The Commission has issued the enclosed Amendment Nos. 49, 49 and 46 for License Nos. DPR-38, DPR-47 and DPR-55, for the Oconee Nuclear Station, Unit Nos. 1, 2 and 3. These amendments consist of changes to the station's common Technical Specifications in response to your request dated October 26, 1977.

OCONEE NUCLEAR STATION, UNIT NO. 1

ATTACHMENT TO LICENSE AMENDMENTS

SAFETY EVALUATION BY THE OFFICE OF NUCLEAR REACTOR REGULATION

FIGURE 3.5.2-6A1

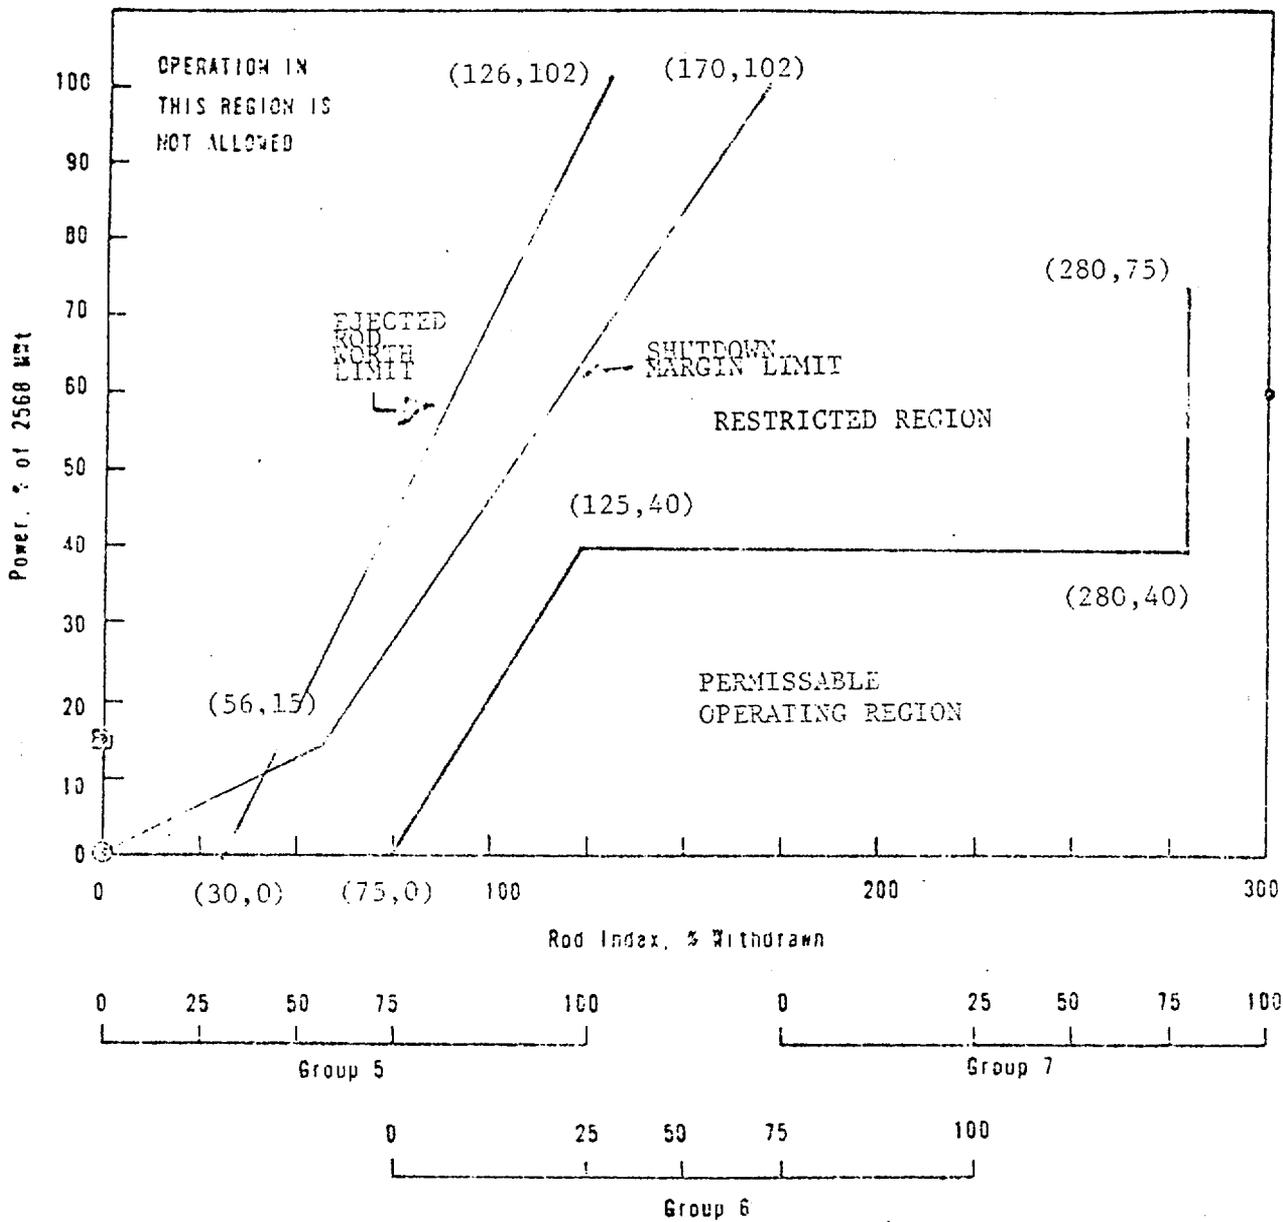
- a. The core thermal power shall be limited to 75 percent full power.
- b. The nuclear power maximum setpoint shall be 84 percent full power.
- c. The quadrant tilt shall not exceed 6.03 percent.
- d. The regulating control rod insertion/withdrawal limits are specified on Figure 3.5.2-6A1

The rod position limits are based on the most limiting of the following criteria: Emergency core cooling system (ECCS) power peaking, shutdown margin, and potential ejected rod worth. The proposed rod position limits are more conservative than those currently in the Oconee Unit 1 Technical Specifications. The licensee has stated that based on maintaining the current power imbalance Specification 3.5.2.6 with the 75% power restriction and the proposed rod position limits, the maximum cladding temperature in the event of a LOCA will not exceed the Final Acceptance Criteria. These proposed rod position limits also ensure the shutdown margin and ejected rod worth criteria are met. The measured and predicted hot zero power values of rod worths were compared and the most restrictive value was used to determine the proposed rod insertion limits. Based on these considerations the proposed rod position limit is acceptable.
